## Product Change Notification / RMES-20LCEZ199

CCB 6369 Final Notice: Qualification of ASE9 as a new final test site for selected ATMEGA16xx, ATMEGA32xx, ATMEGA644xx, and ATMEGA85xx device families available in 44L TQFP (10x10x1mm) package.

**CCB 6369**  
**Pre and Post Change Summary**  
**PCN #: RMES-20LCEZ199**

# Pre and Post Change – Tape and Reel

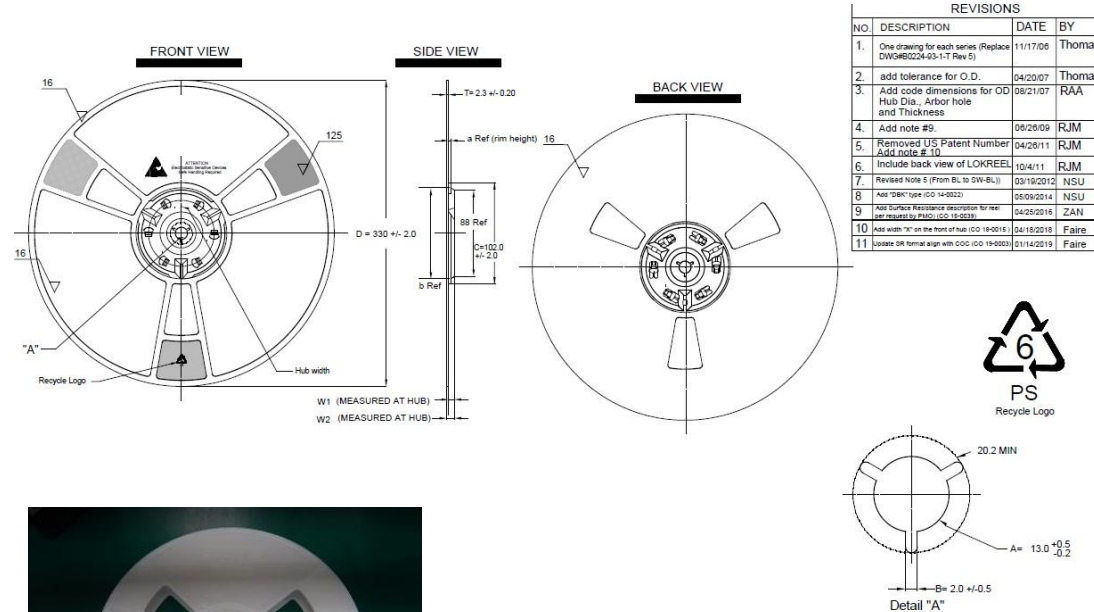
LPI	ASE9
BQM (Base Quantity Multiple)	2000 units per tray	2000 units per tray
Pin 1 orientation	Quadrant 1	Quadrant 1

# Pre and Post Change – Tape and Reel

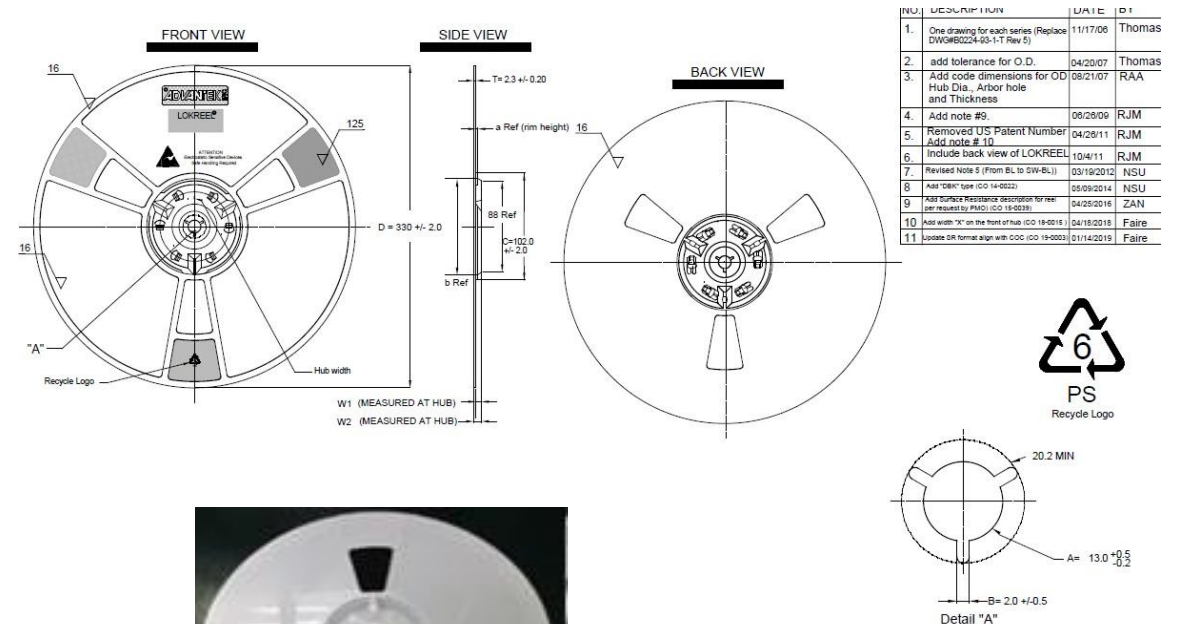
LPI					ASE9				
Carrier Tape										
	Width	Pitch	A0	B0	K0	Width	Pitch	A0	B0	K0
	24mm	16mm	12.35mm	12.35mm	1.65mm	24mm	16mm	12.35mm	12.35mm	1.65mm

# Pre and Post Change – Tape and Reel

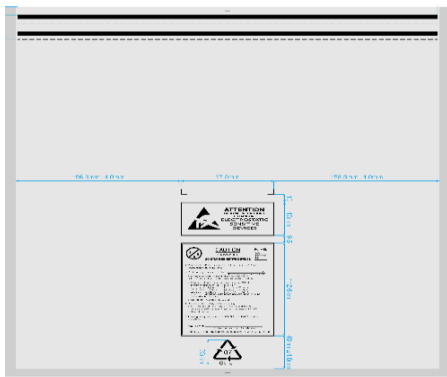
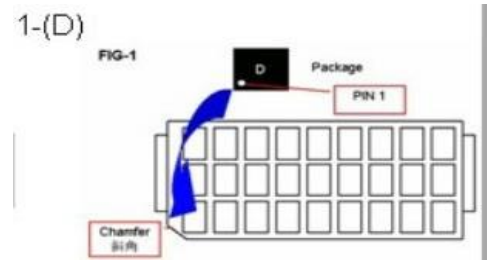
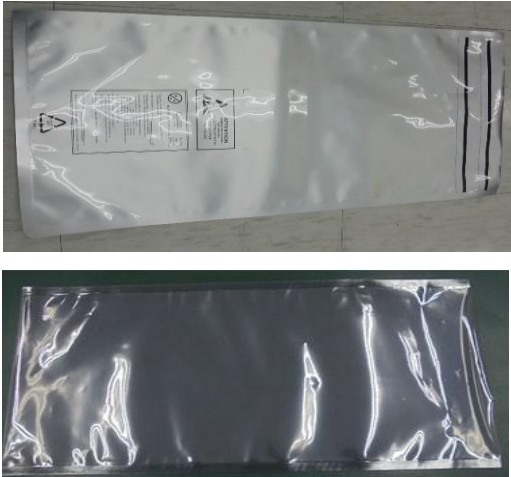
Final Test Site	Color	Diameter	Hub Dia	W1	W2
LPI	White	330	102mm	8.4mm 16.4mm	11.1mm 19.1mm
ASE9	White	330	102mm	8.4mm 16.4mm	11.1mm 19.1mm
